**MARINE RECREATION CENTRE AND WATER ACCESS STRUCTURES AT THE END
OF LAUNCH ROAD: REFERENCE - BUN60349817
HG REF: 1020-143449-01**

This letter provides our response to the additional information you have requested in the letter dated 23 January 2020. For ease of reference we have ordered our response in the same format as your 23 January letter and for the most part our responses also flow from your requests.

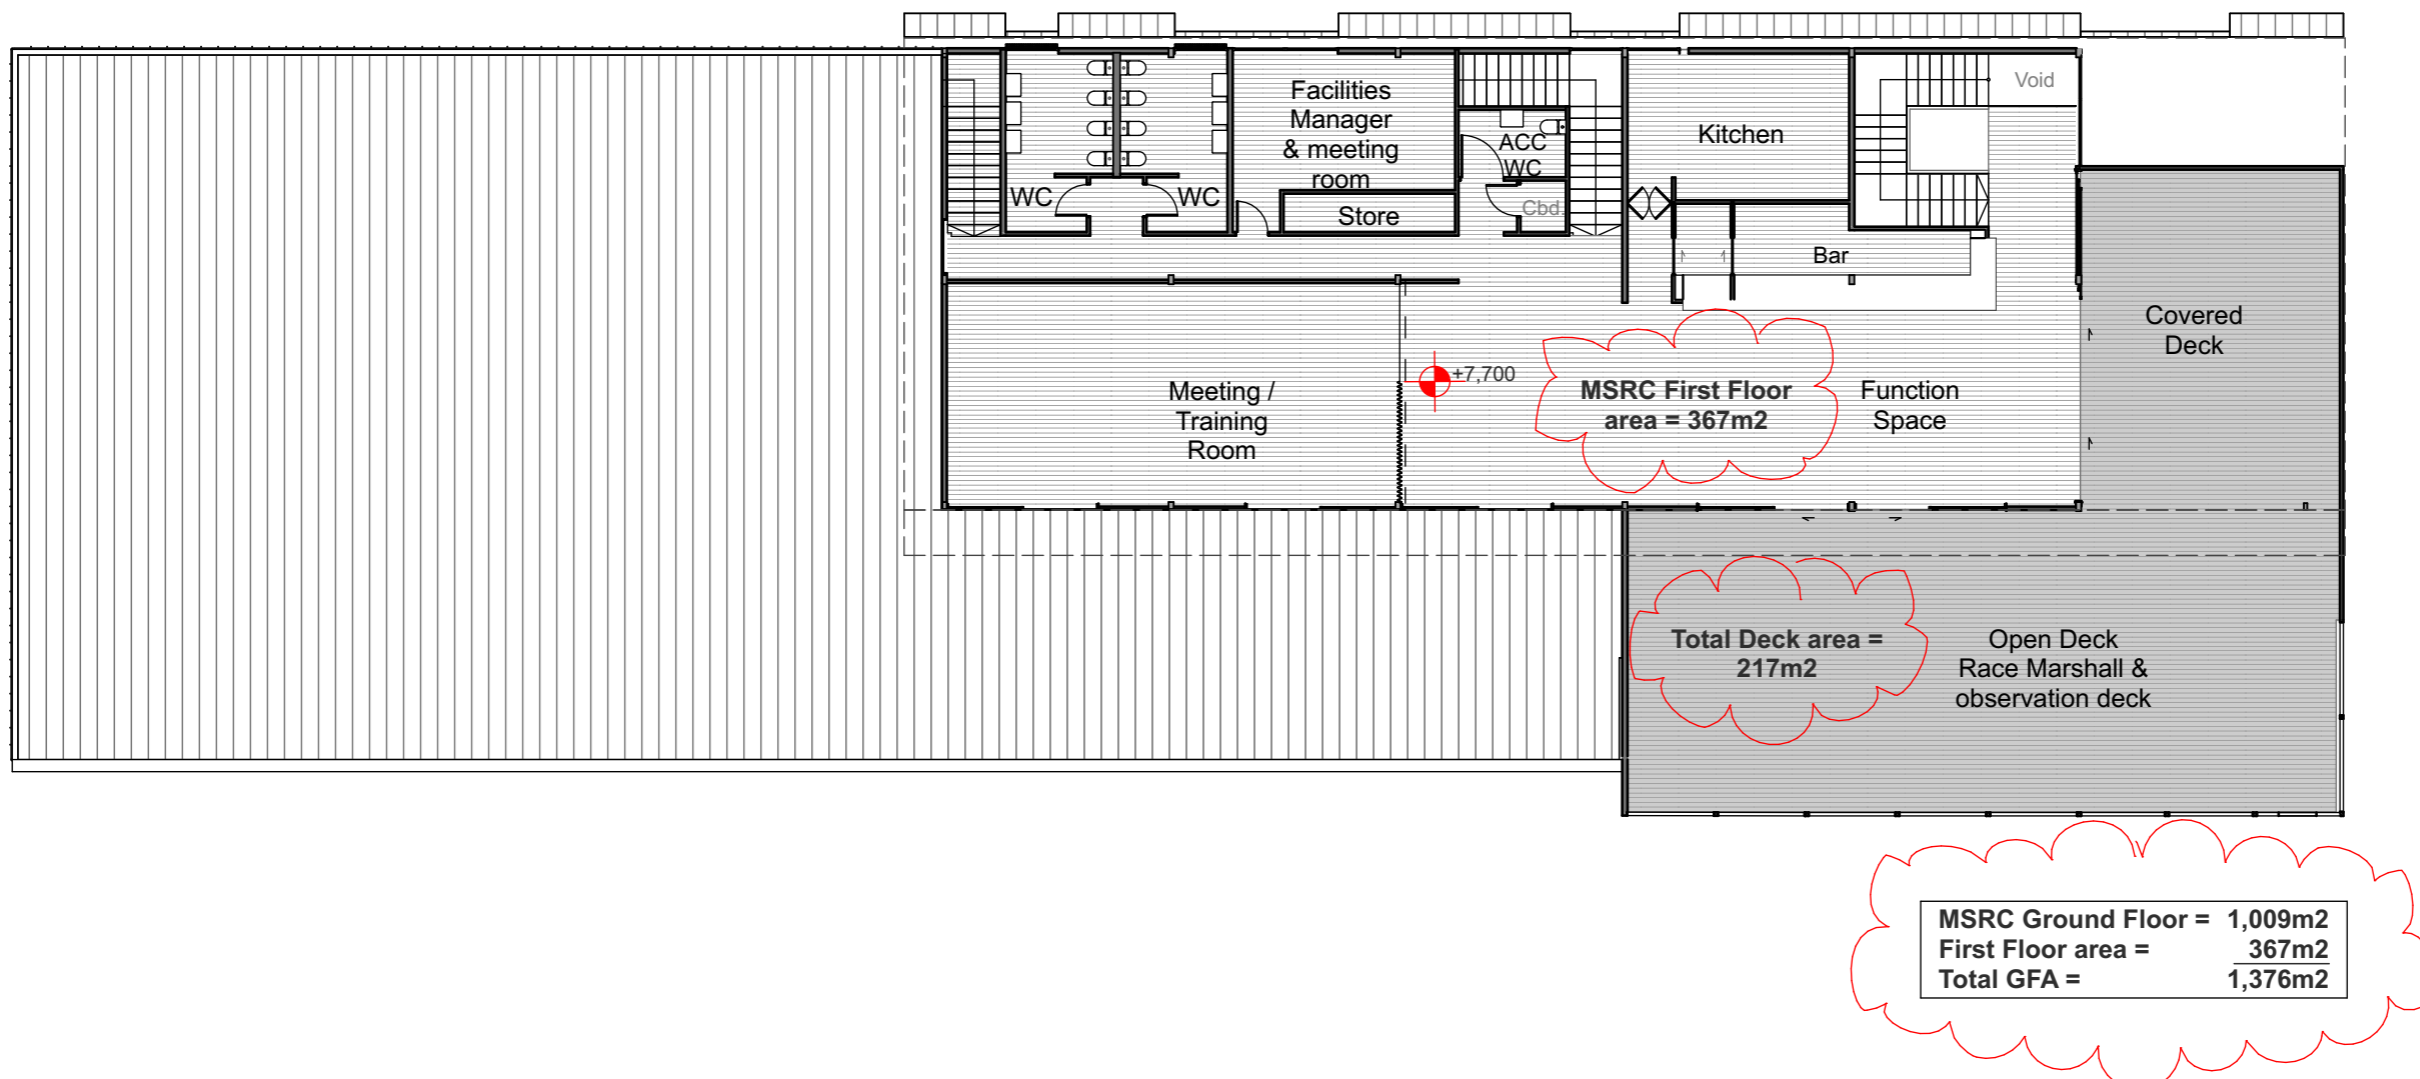
- a) 1,009m² (enclosed building) + 139m² (covered deck). The total building coverage is approximately 1,148m²
- b) The GFA figures are contained on updated plans RC06-A and RC07-A. The total GFA is approximately 1,376m²

MSRC Ground Floor = 1,009m2
 First Floor area = 367m2
 Total GFA = 1,376m2

North East Elevation

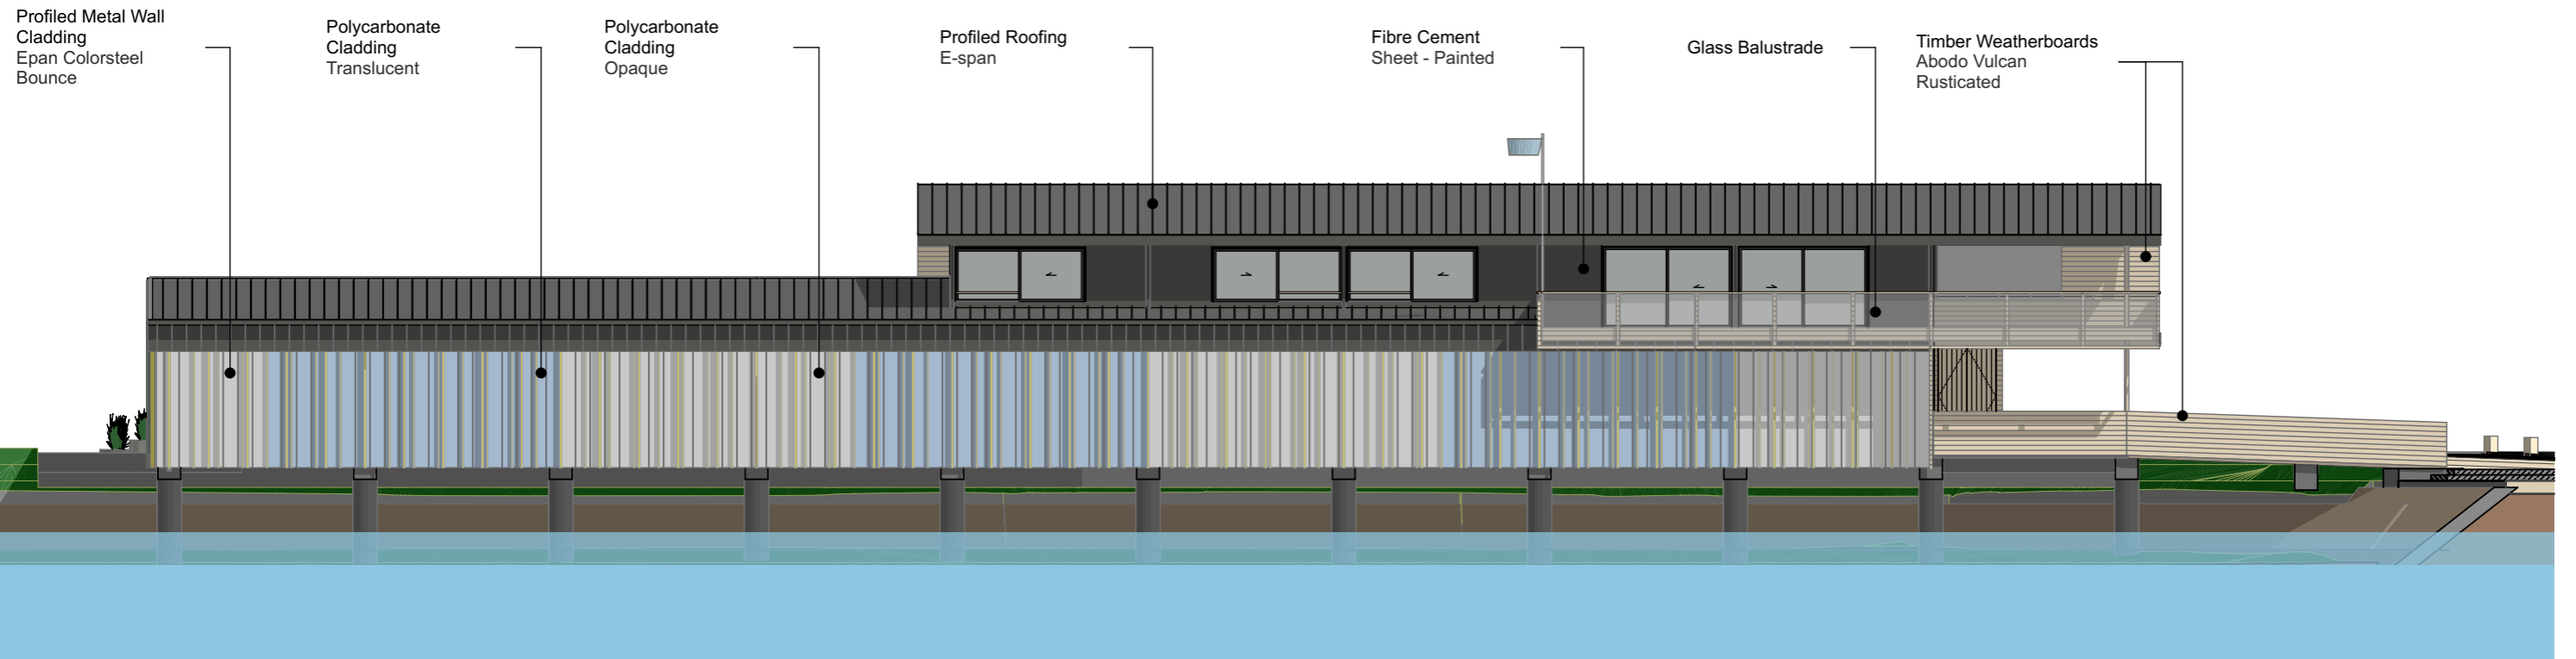
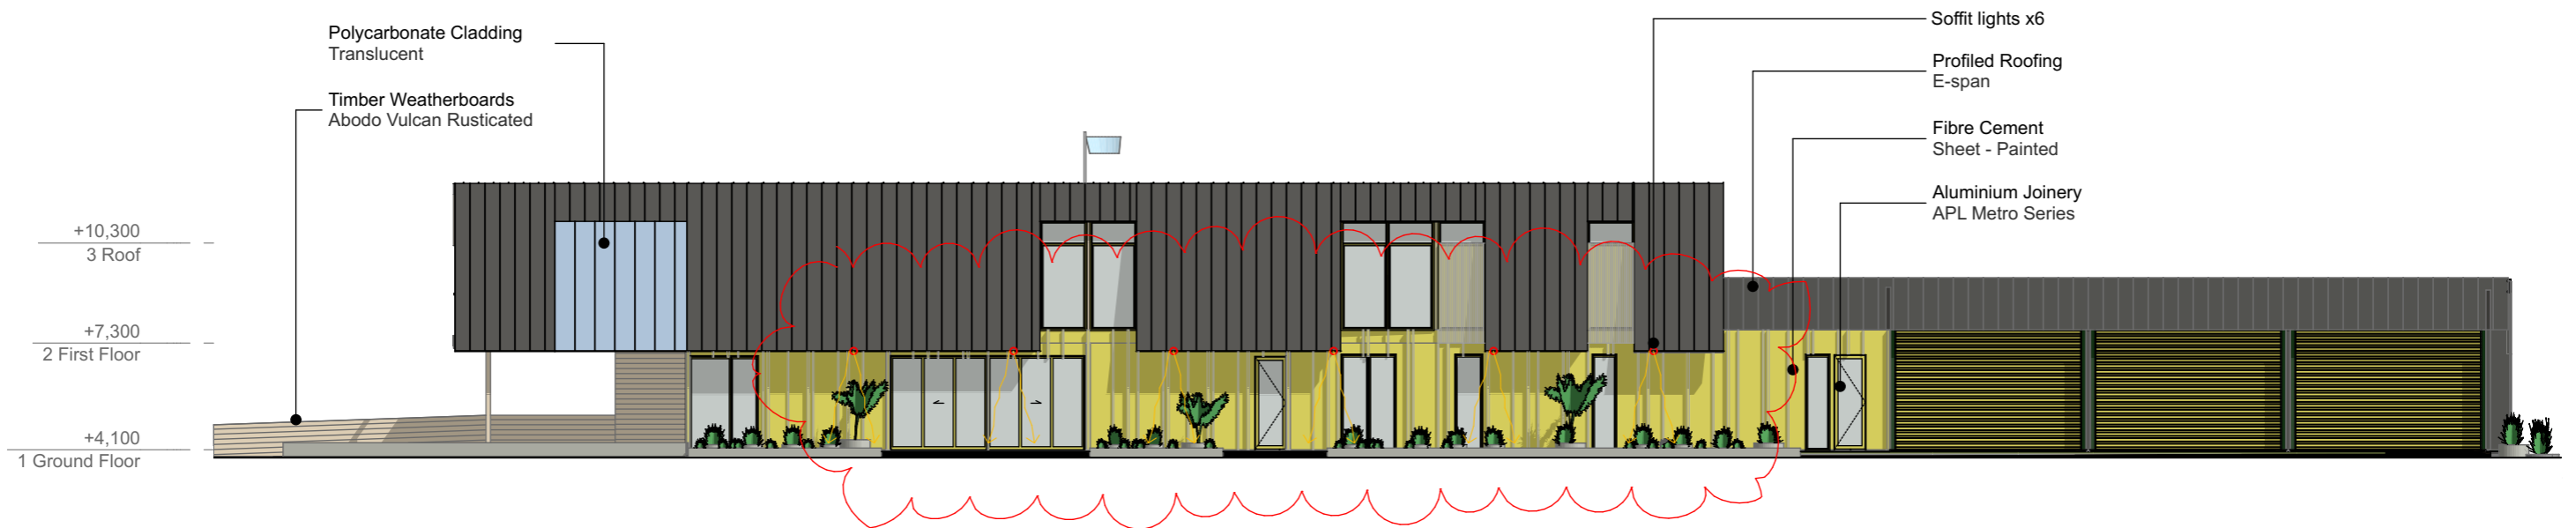
- d) Please refer to the updated SGA drawings RC08-A & RC09-A. The North East & South West Elevations have been extended to include the relationship to the coastal walkway and vegetated bank to the west, dimensions and levels.
